ADMINISTRATIVE AMENDMENT

FILE # _____ PROJECT # _____

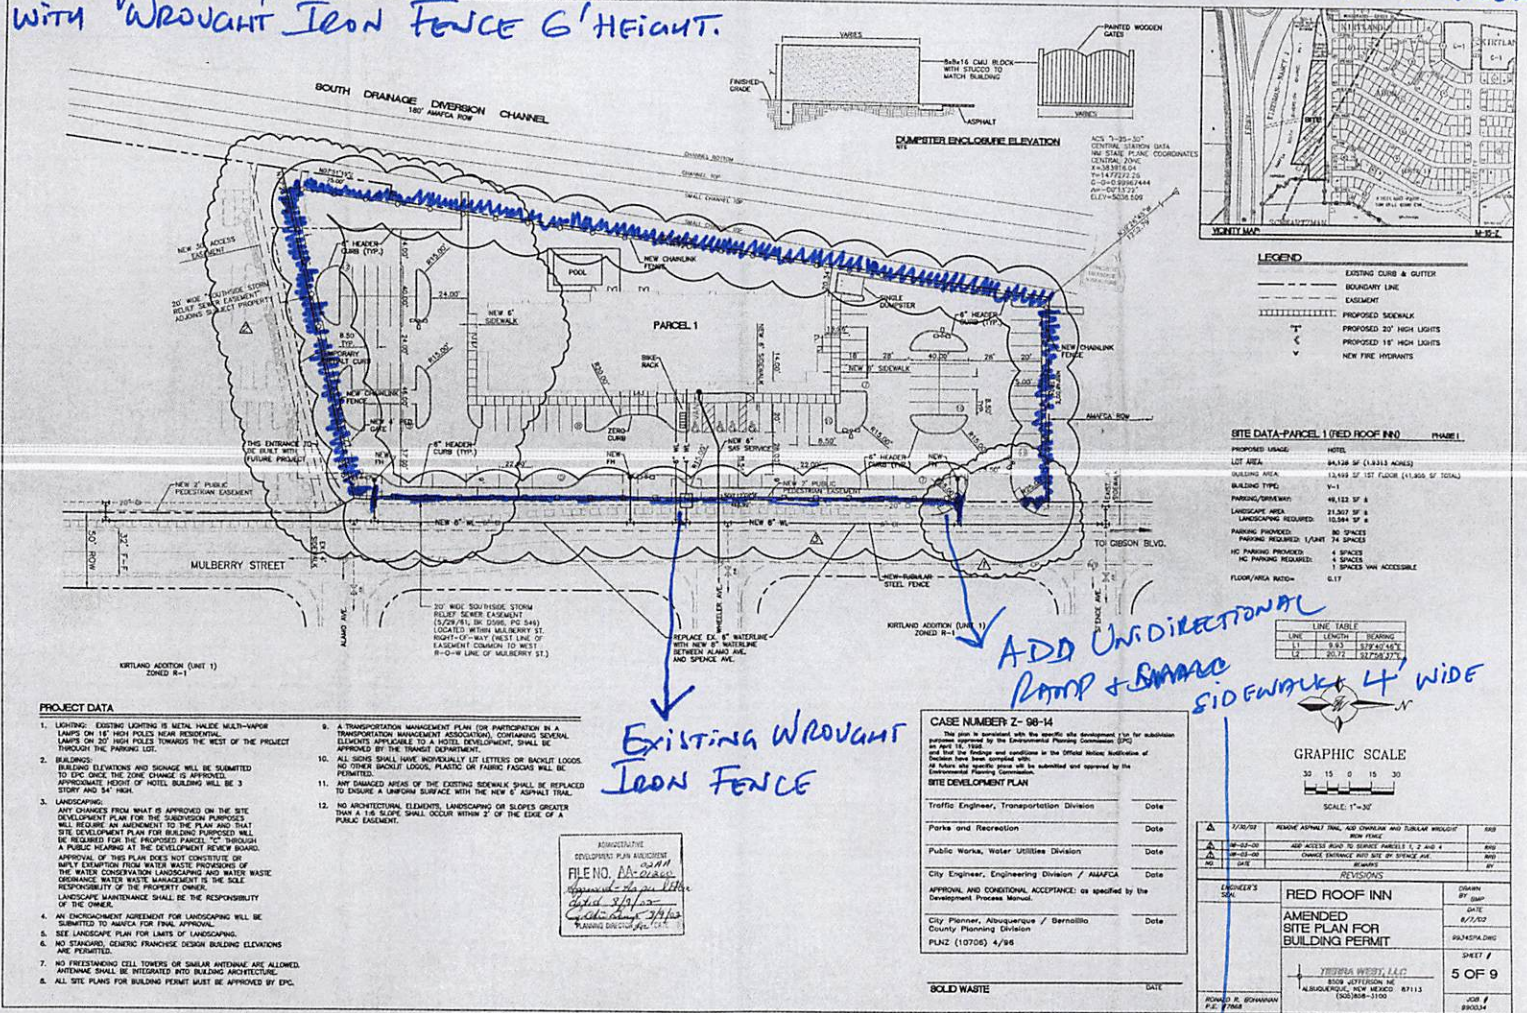
AREA / PROPERTY LINE MARKED WITH EXISTING CHAINLINK FENCE TO BE REPLACED WITH WROUGHT IRON FENCE 6' HEIGHT.

ADD UNIDIRECTIONAL RAMP + SIGNAGE SIDEWALK 4' WIDE

WROUGHT IRON FENCE ILLUSTRATION

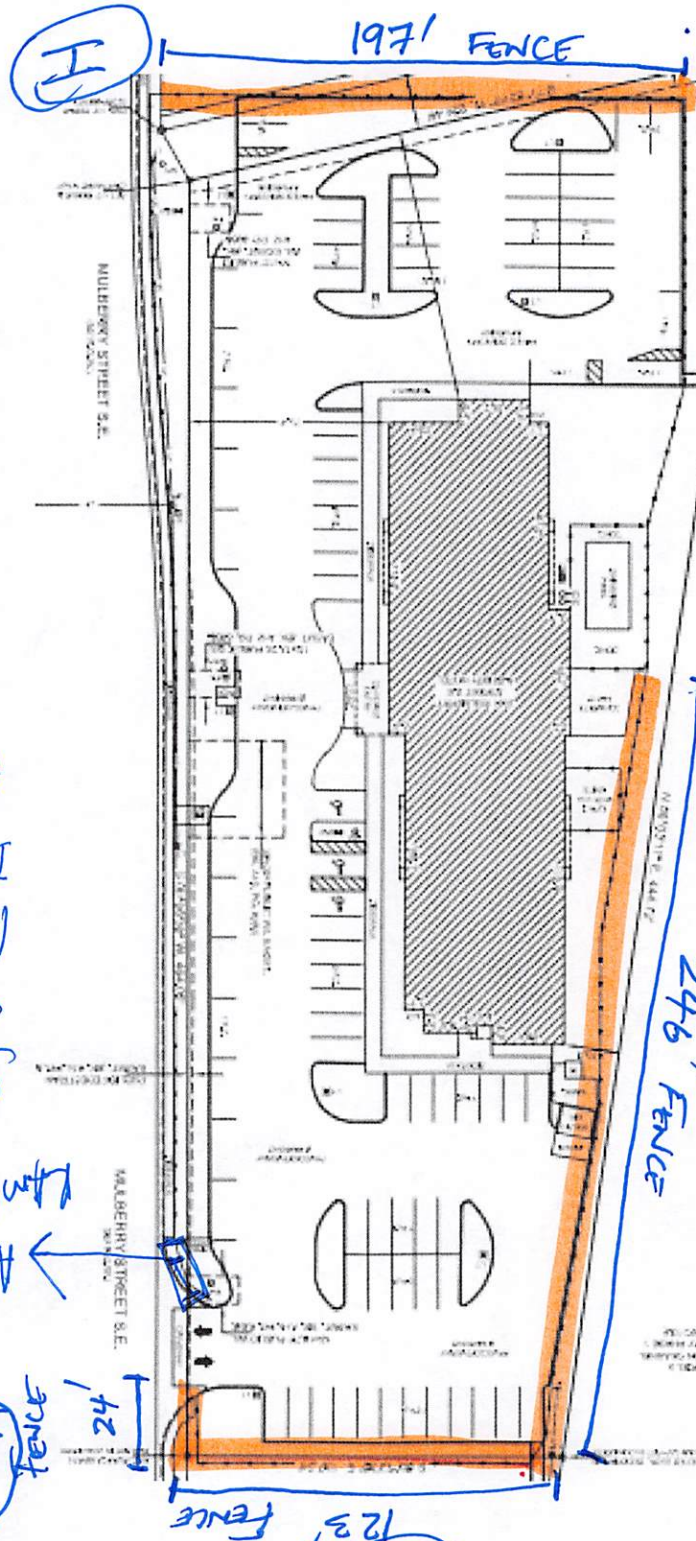
SIDEWALK per COA Std. Dwg. 2430 and RAMP per COA Std. Dwg. 2426, TIE TO EXISTING SIDEWALK.

HIGHLIGHTED AREA IN ORANGE HAS EXISTING 6' CHAIN LINK FENCE + WILL BE REPLACED WITH 6' WROUGHT IRON FENCE WITH 4" SPACING.

ADD UNIDIRECTIONAL
 RAMP + SIDEWALK 4'

6' HEIGHT ALL
 FENCE
